May 15, 2000

Subject: L.E. Carpenter & Company (LEC) - NJD002168748  
NJDEP Review of the MW19/Hot Spot 1 Area Remedial Investigation Report

**FIGURE 1**

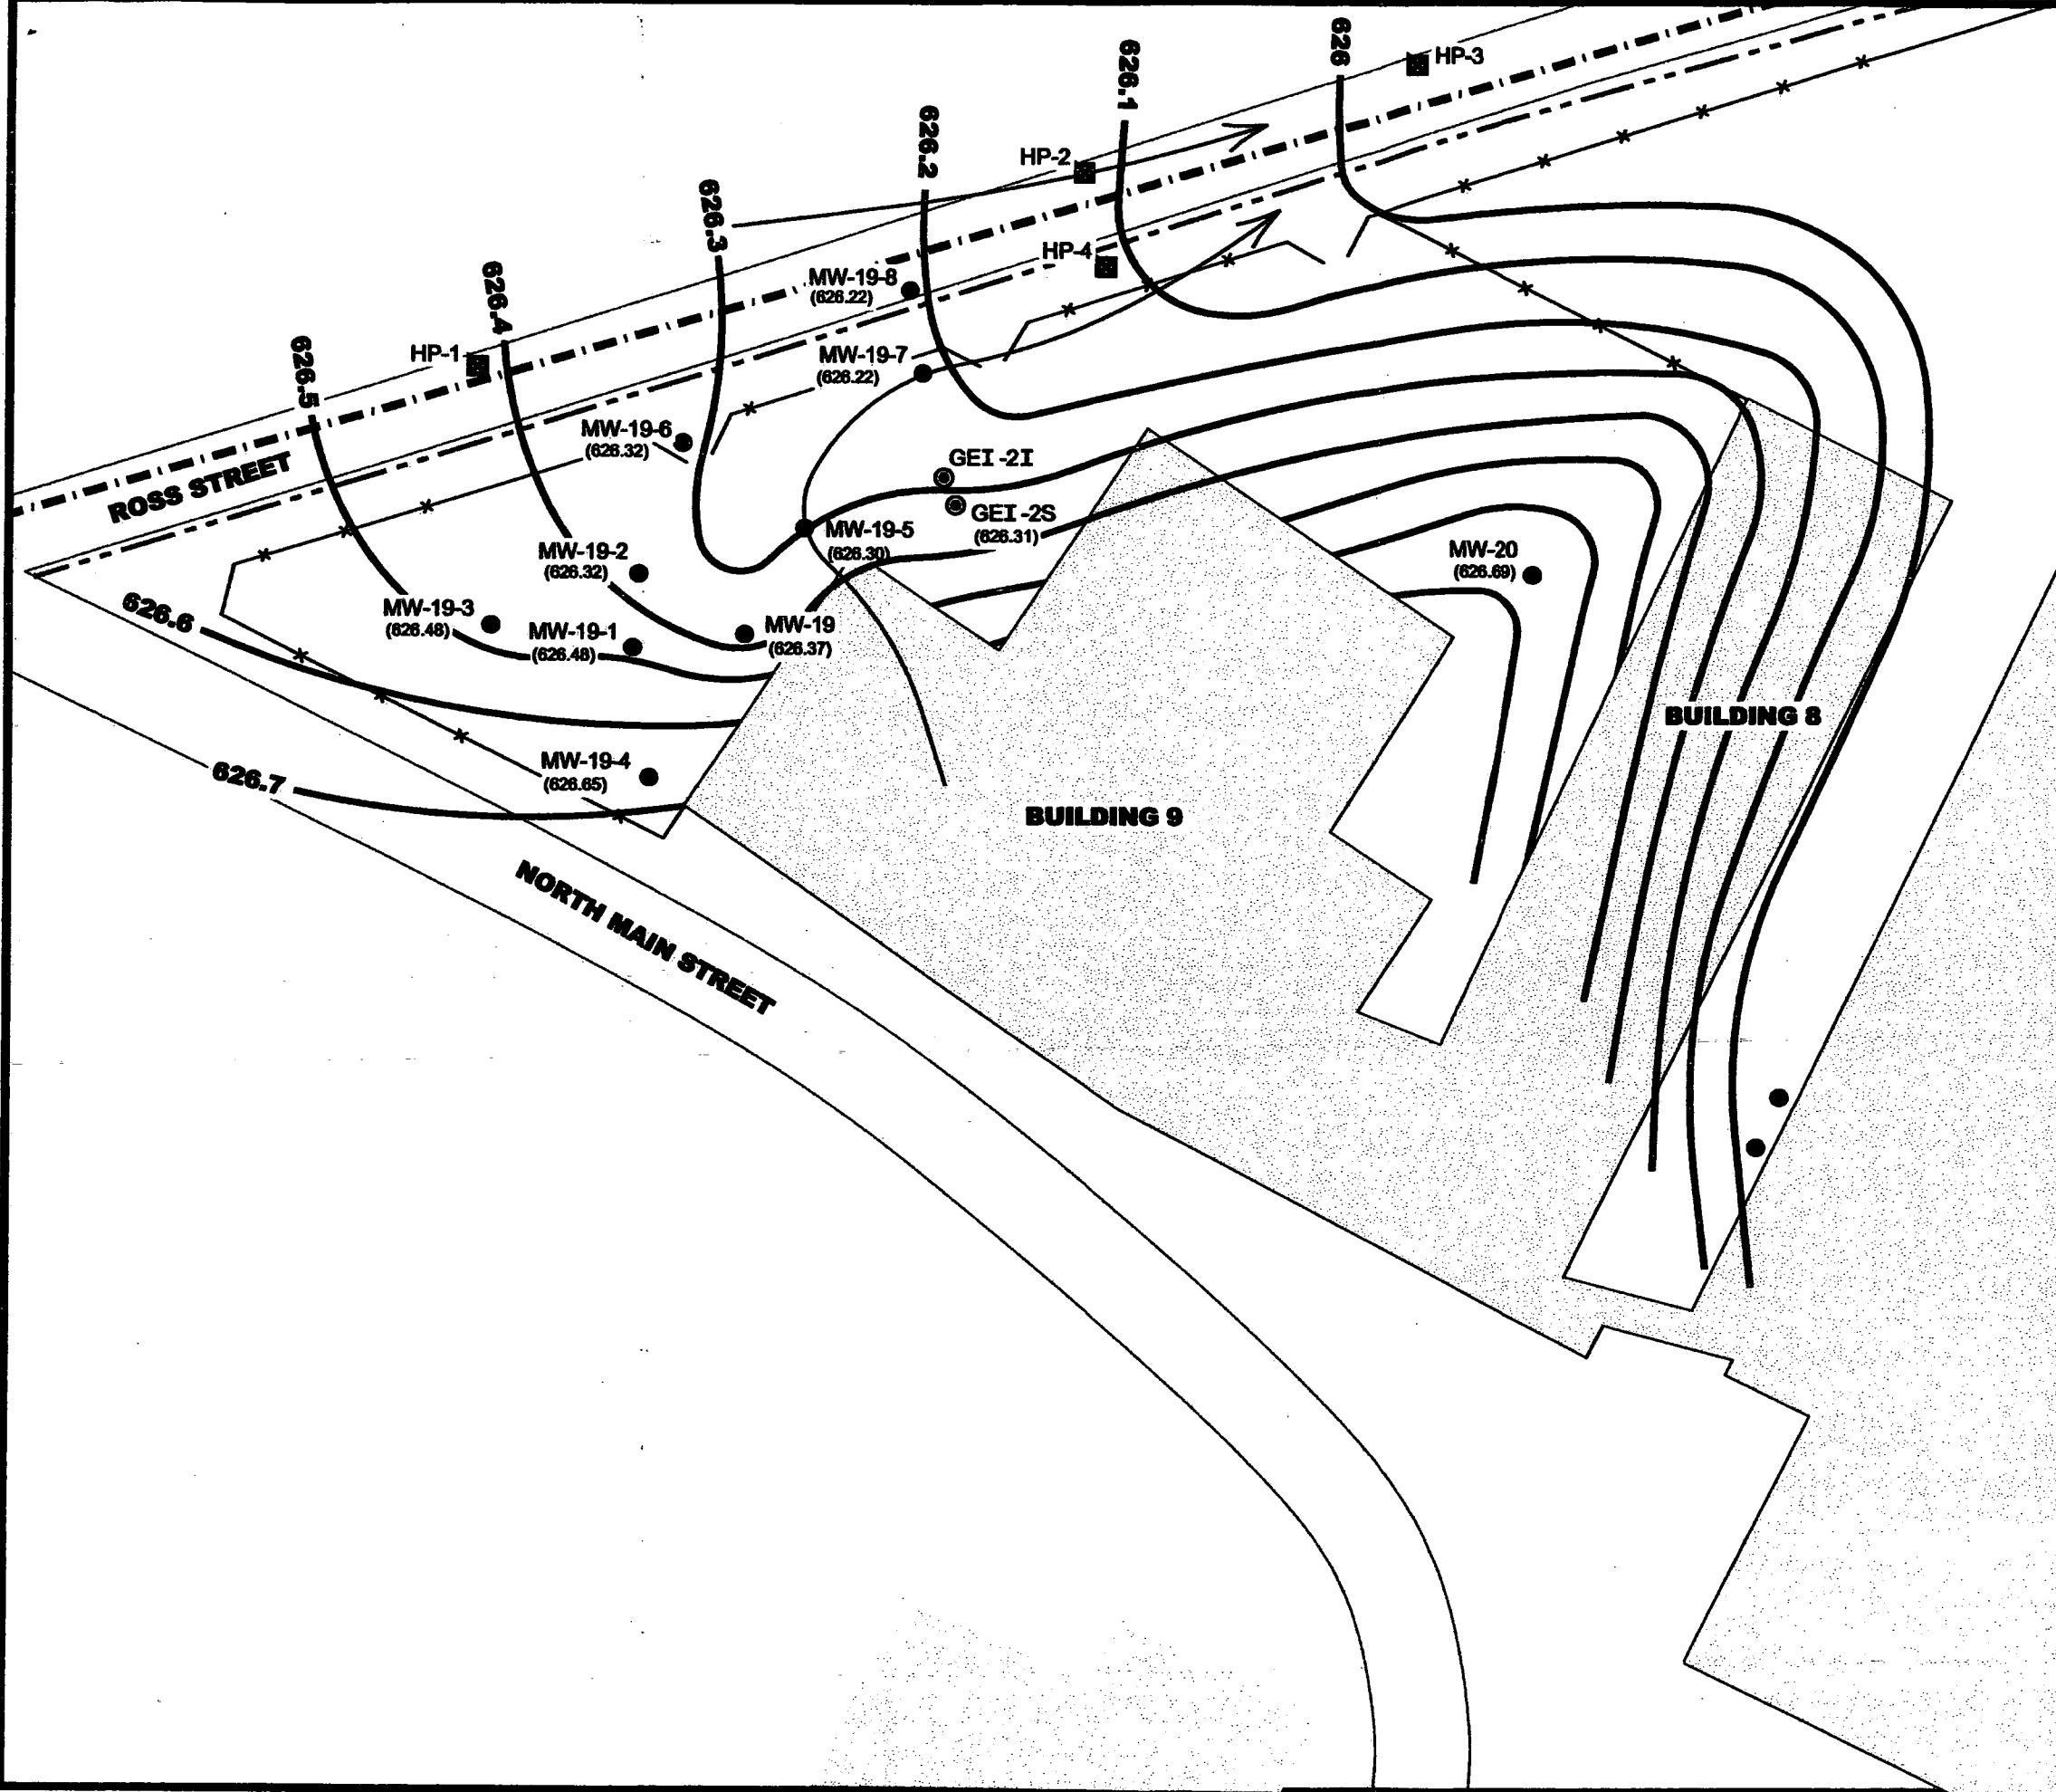
The NJDEP April 13 letter states that MW-19-8 was installed south of the originally proposed location and that it may not be positioned at the most downgradient point necessary to intercept the contaminant plume. In addition, the letter states that exceedences of groundwater quality criteria in MW-19-6 and MW-19-7 means that a "clean zone" was not established. However, based on the data collected to date, RMT believes that complete delineation has been achieved and that no further wells are necessary for delineation purposes at this time. The following information is provided to further support and clarify our position on this matter.

Section 2.2 of our March 2000 report describes the presence of the 24-inch diameter Rockaway River Regional Interceptor Sewer with a gradient from southwest down to the northeast directly underneath Ross Street (Figure 1). The actual location of the interceptor sewer was determined after discussions were held with Mr. Ron Piccolo of Elston T. Killam Associates, Inc., Milburn, New Jersey (Killam). RMT requested and received a copy of the interceptor sewer plan from Killam. The sewer plan and profile is included as Appendix D in RMT's

According to the plan and profile the sewer line is constructed over 6-inches of stone base. In addition, based on previously measured groundwater elevations, the profile shows that the sewer line intercepts the water table about 70 feet northeast of manhole W-16, which is located about 50 feet southwest of Hydropunch location HP-1 (Figure 1). This information indicated that the sewer line would likely act to intercept and control shallow groundwater flow. If this were indeed the case, analytical results received from any wells installed on the northwest side of the sewer line would represent the quality of groundwater flowing towards the sewer line from the area north of the sewer, and would not be representative of groundwater migrating from LEC. On the day of well installation, RMT observed that the proposed location for MW-19-8 (the assumed furthest downgradient well) was too close to the sewer line to allow safe drilling. Based on the above information, RMT field-located all three monitoring wells approximately 20-feet southeast of the originally proposed locations.

The MW-19/Hot Spot 1 area groundwater elevation contours are shown on Figure 1, and verify that groundwater is intercepted by the regional sewer line. Groundwater flow at the northwest end of Building 9 is northward under a hydraulic gradient of approximately 0.01 feet/foot. Groundwater flow direction in the immediate vicinity of the sewer line is to the east-northeast under a hydraulic gradient of approximately 0.002 feet/foot. Such a decrease in hydraulic gradient is consistent with an influence on groundwater flow by the sewer lines' coarse-grained, high permeability stone base.

The groundwater flow directions and contaminant distributions both show that wells MW-19-7 and MW-19-8 are adequately positioned to monitor groundwater quality downgradient from the MW-19/Hot Spot 1 area at LEC.

FIGURE 2

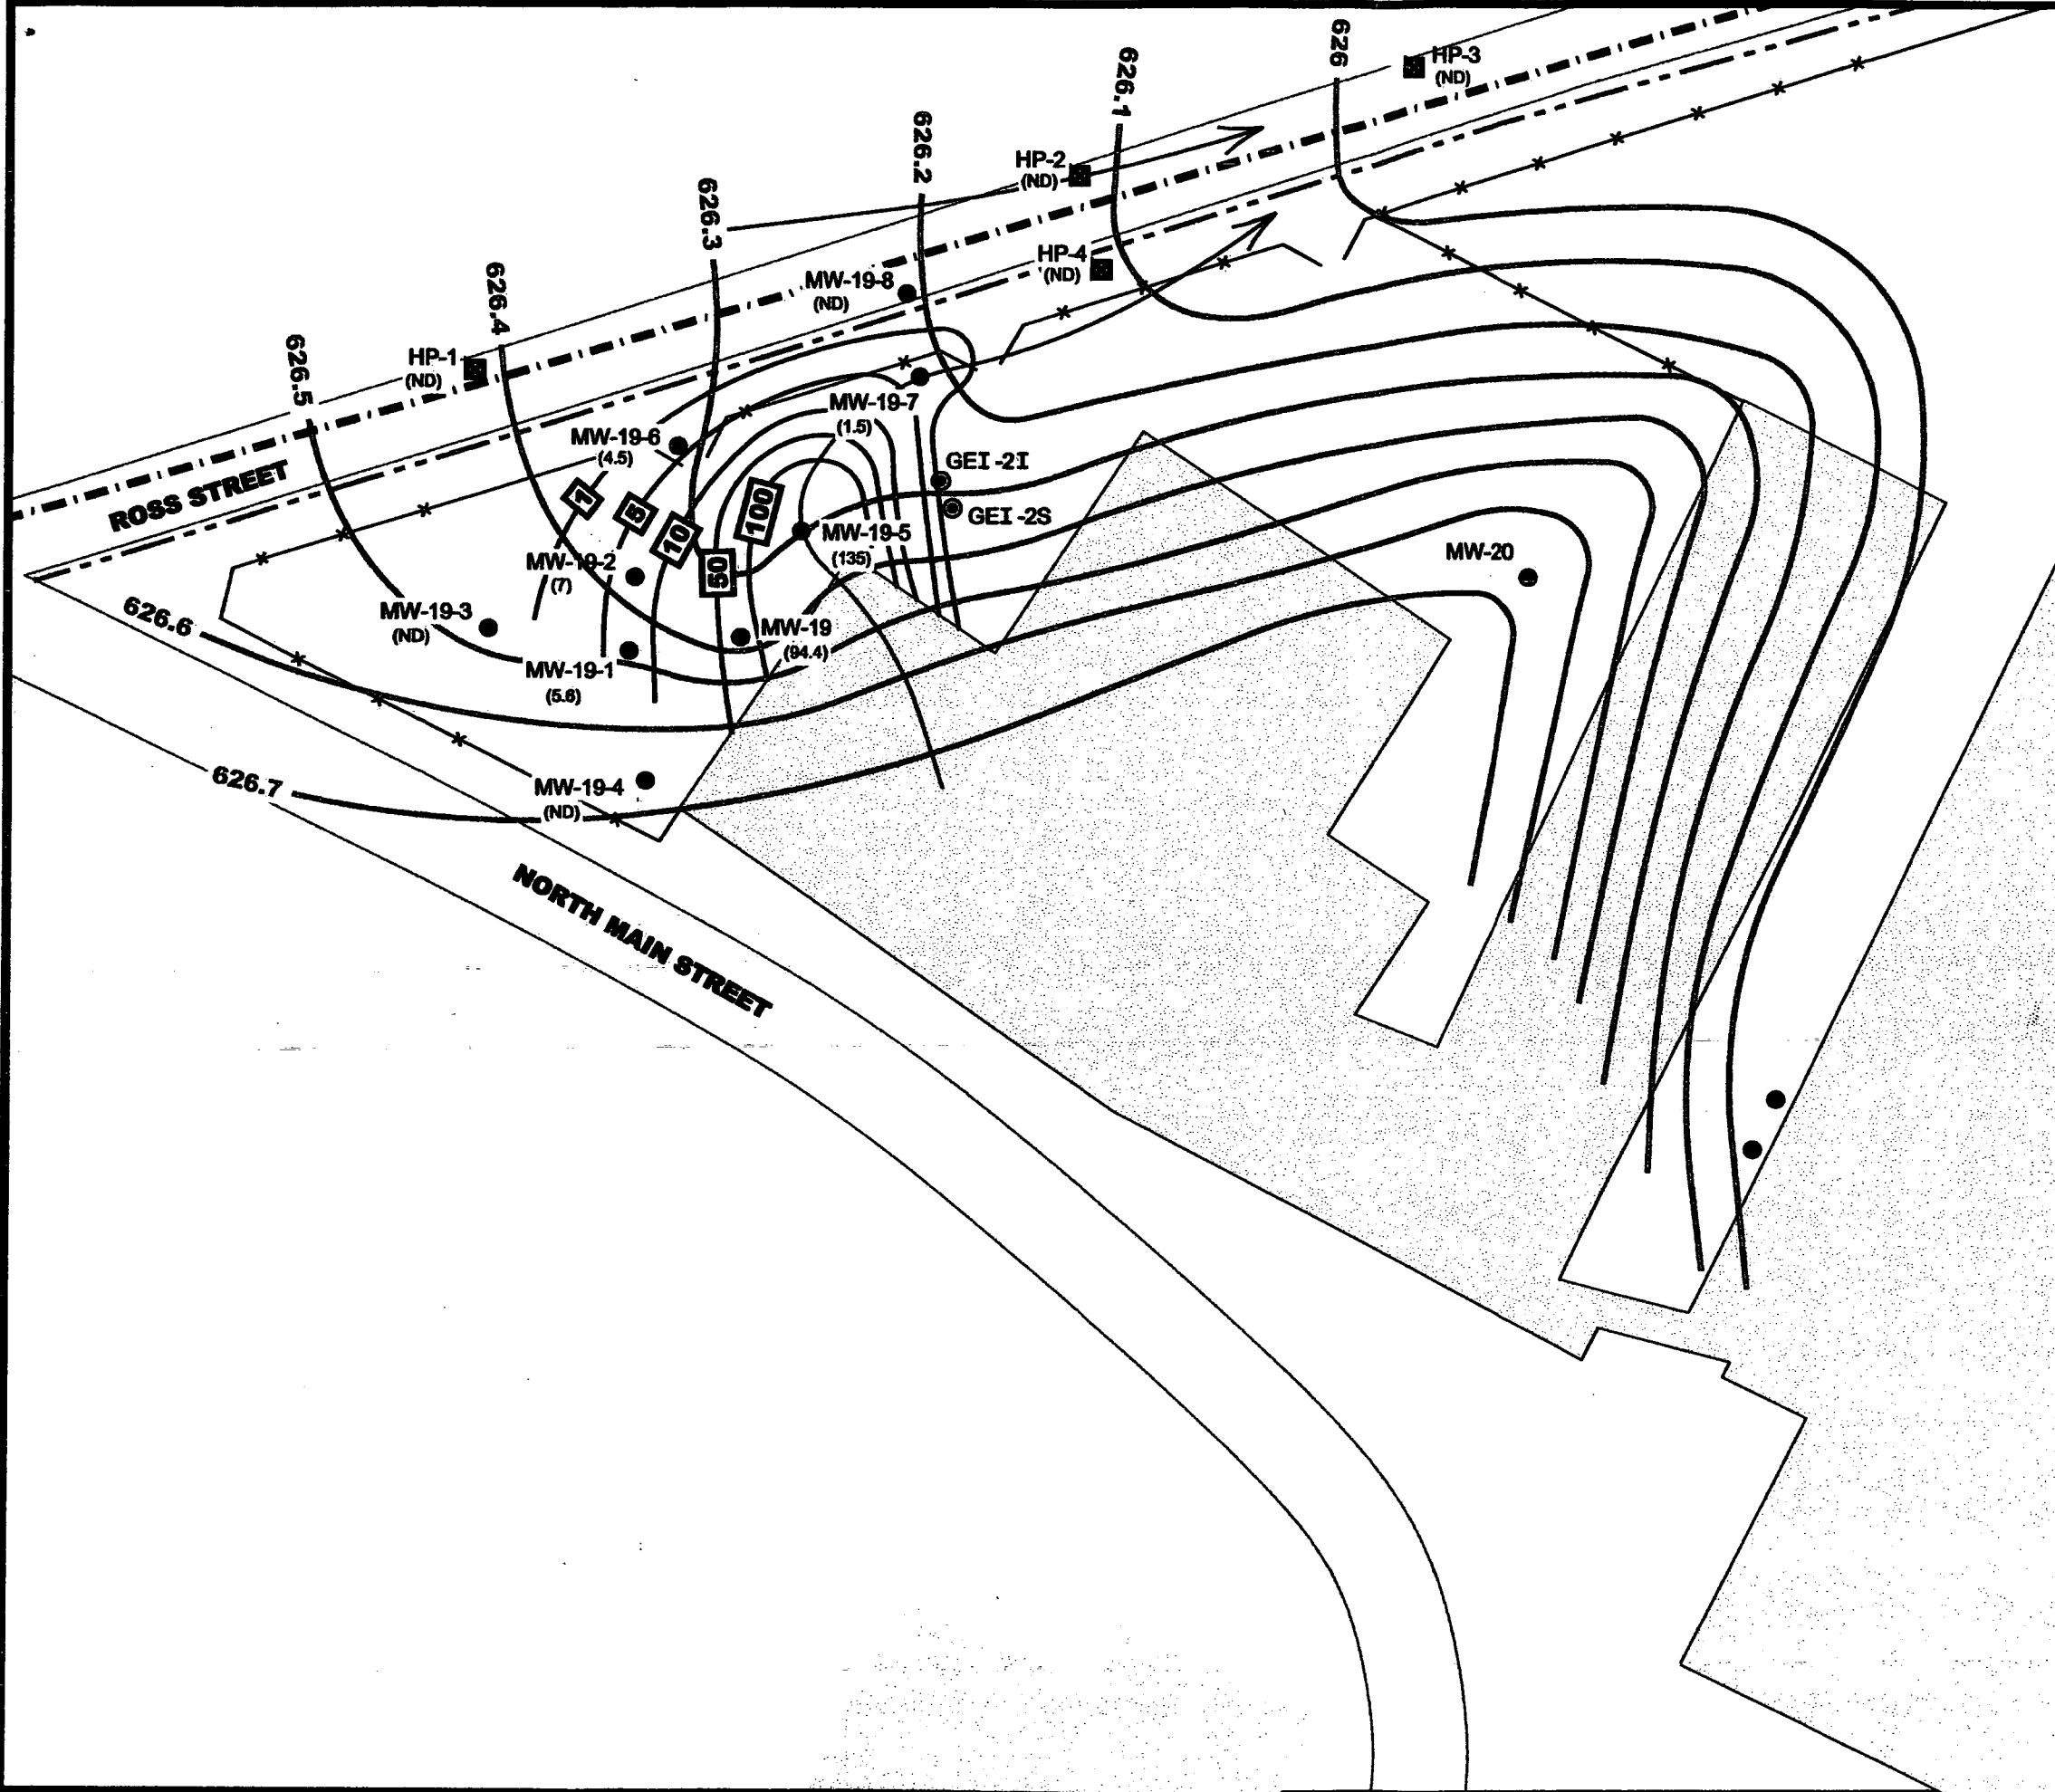
It is true that benzene may be present above a level of 1 ppb in MW-19-6 and MW-19-7. However, as shown on Figure 2, MW-19-7 defines the downgradient edge of the contaminant plume. None of the constituents of concern were detected in the shallow groundwater sample from HP-4, which was located immediately downgradient from MW-19-7.

The groundwater flow directions are also consistent with the distribution of contaminants in the shallow aquifer. Isoconcentration contours for total BTEX levels (mg/L) are shown on Figure 2 with respect to the groundwater elevation contours. The isoconcentration lines are predominantly perpendicular to the groundwater elevation contours, and thus are in good agreement with the groundwater flow directions of Figure 1.

RMT recommends that no further delineation work be performed in the MW-19/Hot Spot 1 area. Future monitoring should be performed at the frequency stipulated in the ROD. We also recommend development of a monitoring program for this area that will utilize results from the recently completed natural attenuation study that has been submitted under separate cover.
